Project	IEEE 802.16 Broadband Wireless Access Working Group < http://ieee802.org/16 >	
Title	RS network entry procedure	
Date Submitted	2007-03-15	
Source(s)	<p>Mike Hart, Yuefeng Zhou, Sunil Vadgama Fujitsu Laboratories of Europe Ltd. Hayes Park Central Hayes, Middx, UB4 8FE, UK</p> <p>Sungjin Lee, Hyunjeong Kang, Hyoungkyu Lim Samsung Electronics</p>	<p>Voice: +44 20 8606 4523 Fax: +44 20 8606 4539 mike.hart@uk.fujitsu.com</p> <p>Voice: +82 31 279 5248 Fax: +82 31 279 5130 E-mail : steve.lee@samsung.com</p>
Re:	Call for technical proposals 802.16j-076/007r234	
Abstract	<p>This contribution provides a technical proposal for the RS network entry procedure for the case of a non-transparent RS. It is based on reusing many of the stages executed in the SS network entry procedure with the only major change being the introduction of new SBC and REG TLV values to enable exchange of information about PHY & MAC features supported by the RS. It also defines how the RS switches from using the access link to using the relay link following successful registration with the MR-BS.</p>

RS network entry procedure

Figure 2. RS network entry procedure.

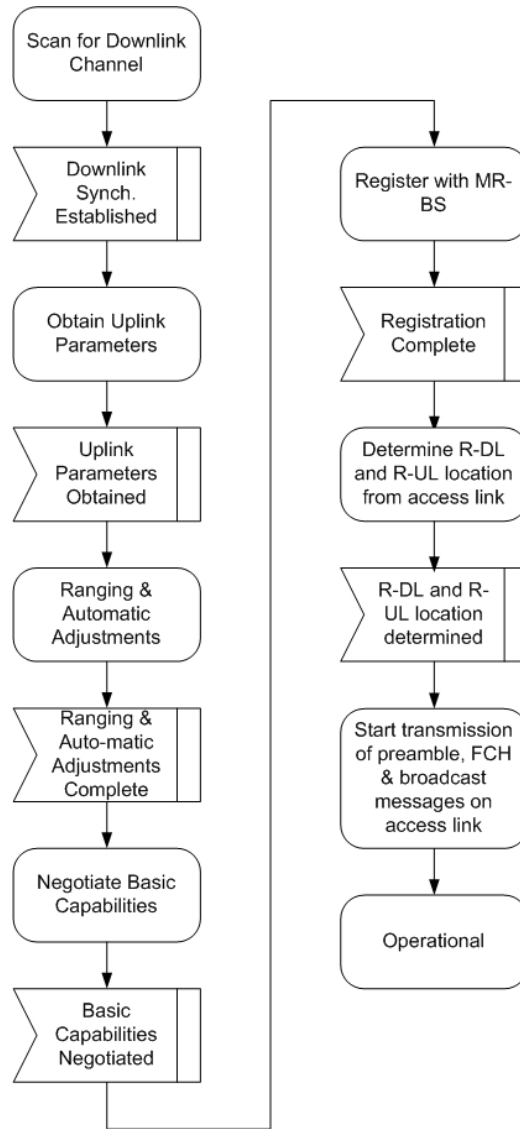
It is assumed that the network could consist of some IEEE Std. 802.16 BS and some MR-BS. It is also assumed that a MR-BS may be operating in a legacy mode until it receives a request from an RS for it to enter the network. The reason the BS may operate in such a mode would be to preserve transmission resources.

However, it is proposed that the MR-BS will at least broadcast the MAC version support TLV [1] indicating its capability to support the IEEE 802.16j MAC in the DCD message. The RS will then be able to identify that the BS is in fact an MR-BS at an early stage in the network entry procedure and decide whether to continue once it learns whether it is attempting to connect to a BS or MR-BS.

The RNG process will be unchanged from the used for SS network entry, the only change being that the RS will indicate support of IEEE 802.16j through the MAC version support TLV. The MR-BS will respond indicating that it can support IEEE 802.16j.

Similarly in the SBC process, a new RS capability TLV isare defined to indicate basic capabilities of the RS to the BS. This TLV will identify the type of relay (i.e. transparent, non-transparent, centralized scheduling, distributed scheduling) and also any other MR-BS or RS related features required to support the RS. This TLV is defined in this proposal. By placing it in SBC it allows the RS to abort connection if it finds that fundamental basic parameters are not supported.

The procedure for initialization of an RS shall be as shown in Figure 5555. For the RS the stages e), g), h), i) and j) are not required, for all other stages the RS shall behave in the same manner as an SS during network entry unless otherwise specified in the subclauses of 6.3.9. The more detailed finite state machine representations of the individual sections (including error paths) and the timeout values shall be the same as those provided for the SS, unless otherwise specified.
